**Subject: Metropolitan Mine Mod 4 Longwalls 317 and 318**

Thank you for your request via the NSW Planning Portal dated 28/7/2025 to the Conservation Programs, Heritage and Regulation Group (CPHR) of the NSW Department of Climate Change, Energy, the Environment and Water (NSW DCCEEW) inviting comments on Modification 4 of the Metropolitan Coal Mine consent.

## Mod 4 Metropolitan Coal Mine – Longwalls 317-318

MSEC Figure 3.9

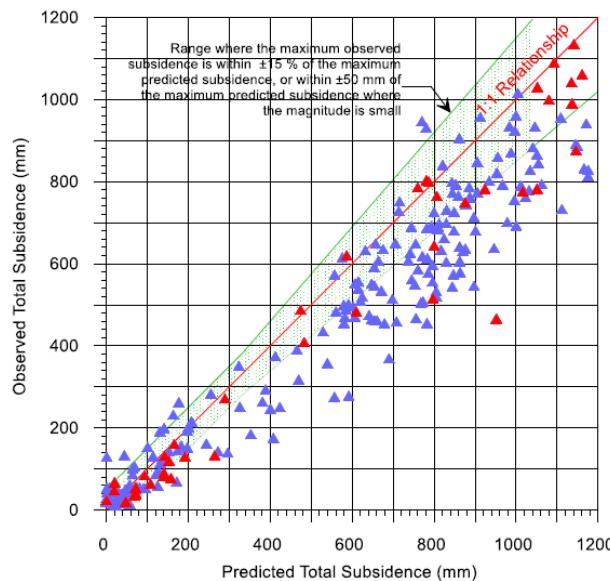
versus predicted subsidence values compared to previous MSEC documents (e.g. the Metropolitan Coal Annual Review 2020 and Metropolitan Mine – 2021 Annual Review Report Subsidence Monitoring Results reports).

Fig. 3.9 Comparisons between Maximum Observed Incremental Subsidence and Maximum Predicted Incremental Subsidence for the Previously Extracted Longwalls in the Southern Coalfield

- 20.1 Identify subsidence thresholds for impact consequences and use these to adjust mine layouts so that impacts to significant biodiversity are avoided and a better balance between coal extraction and environmental impact is achieved.
- 20.2 Clarify subsidence exceedances and refer matter to the IEAPM if necessary.
